City of Springfield

Landmarks Board

November 6, 2024

LANDMARKS BOARD STAFF REPORT

Existing Concrete Porch Plan 3/8" = 1'-0"

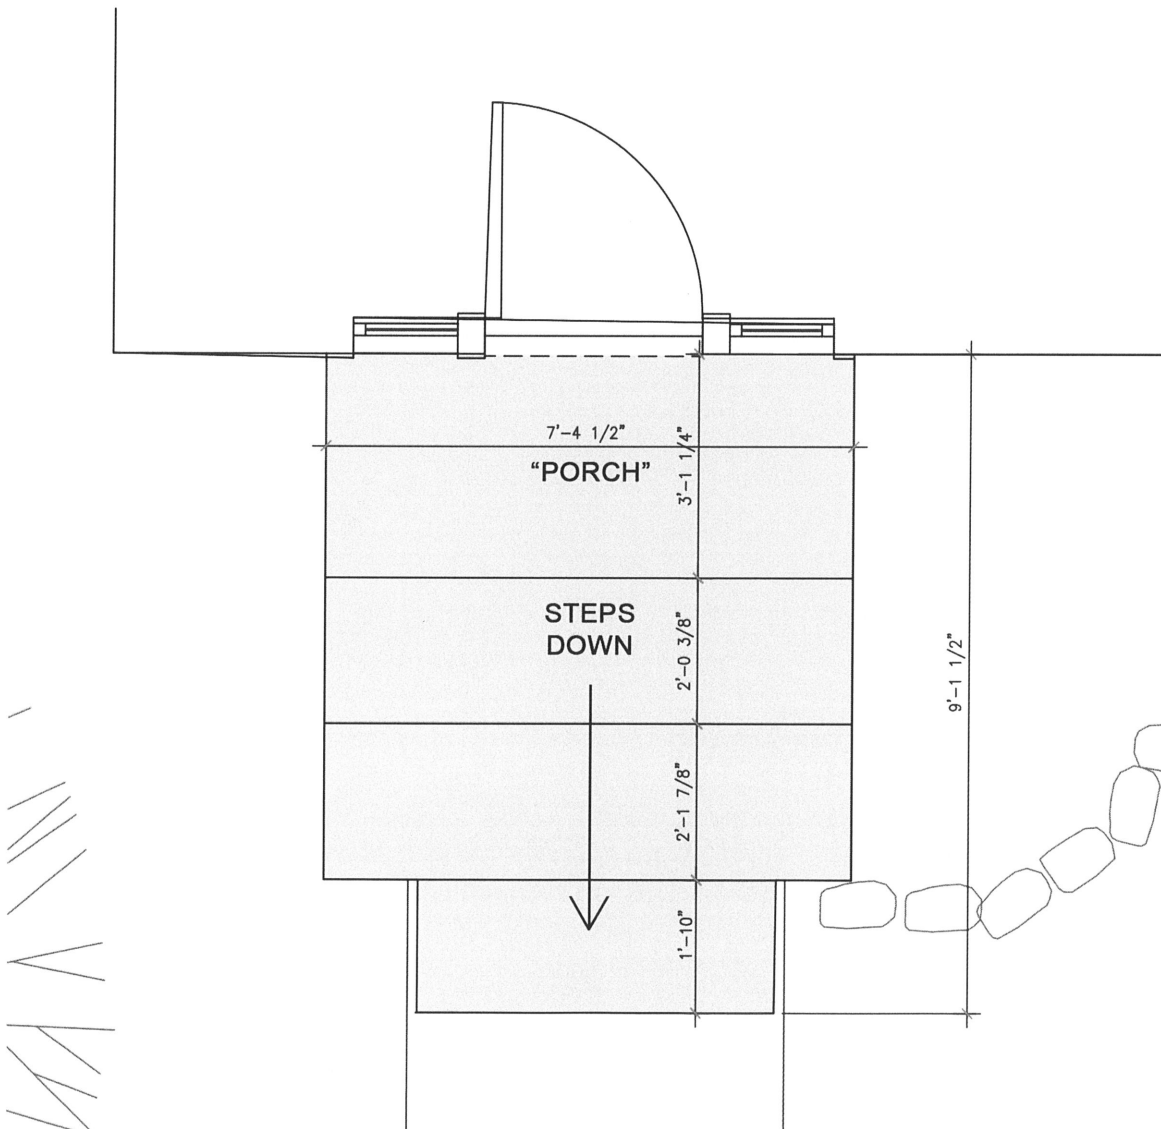
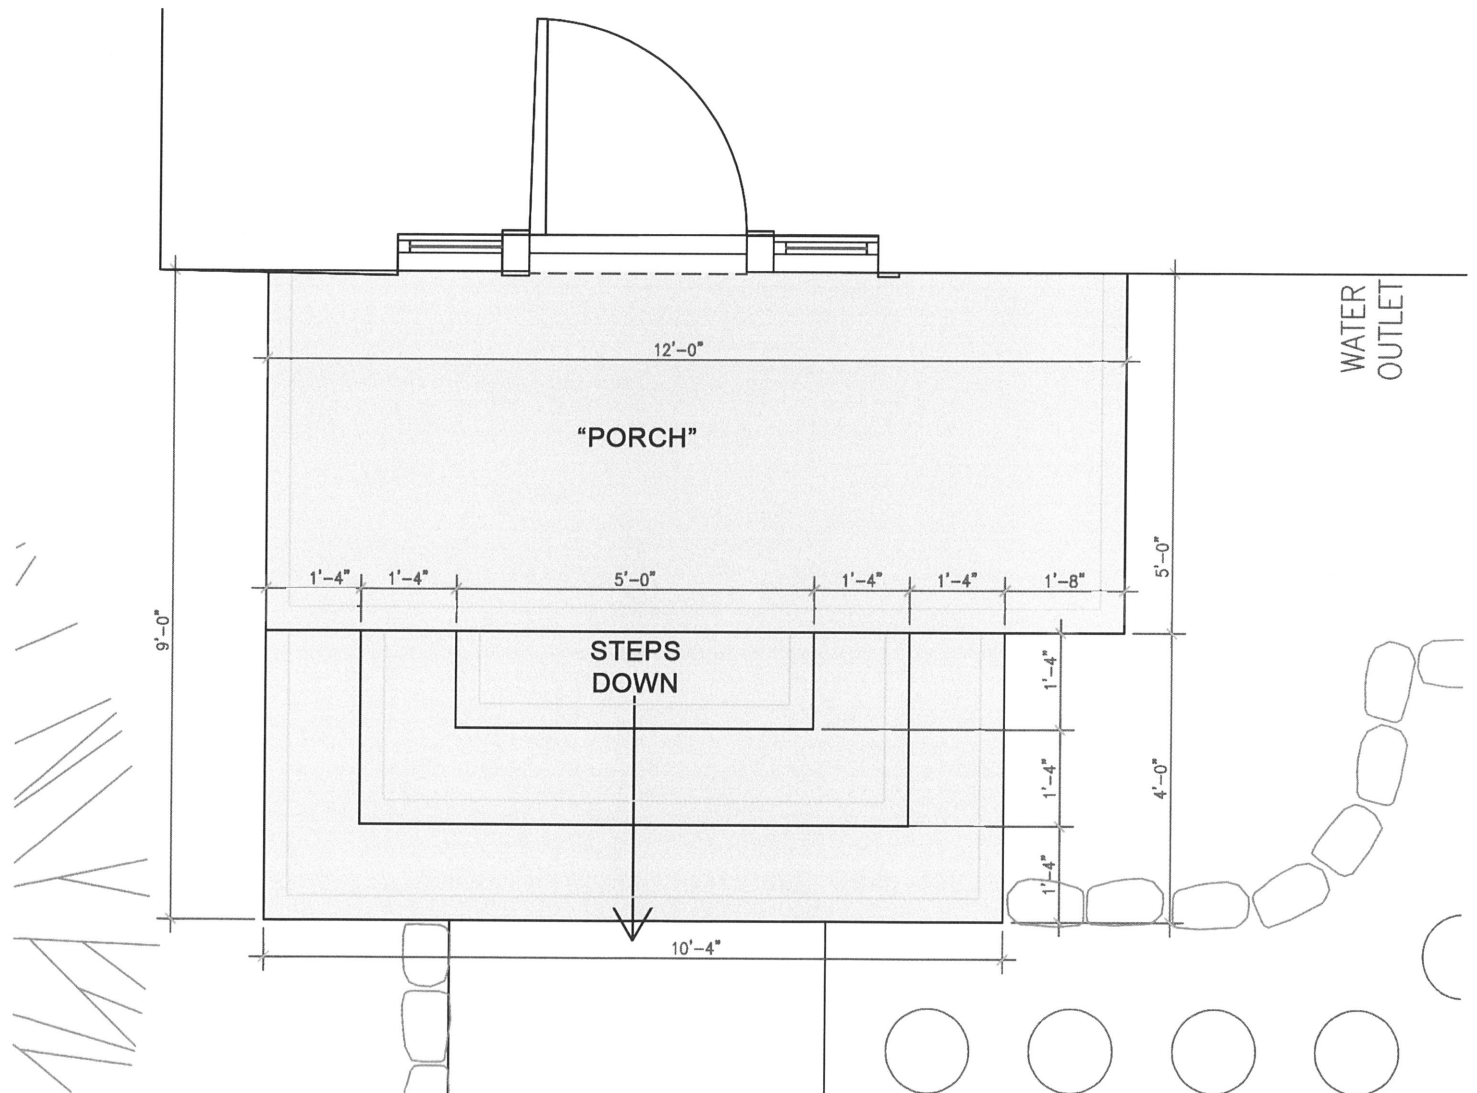
1. The replacement of the porch appears to be consistent with the design guidelines. The existing porch is not original. The new porch is not expected to dominate the property or house.
2. The sidewalk and steps, front retaining wall and replacement of section of driveway are in-kind replacements which is recommended by the Walnut Street Design Guidelines. These items could be approved administratively, however, those items appear in this application to detail the full scope of the project.
3. All proposed work is required to receive a building permit to be issued by Building Development Services. All other requirements of the Zoning Ordinance and Building Code shall apply.

1. Staff recommends approval.
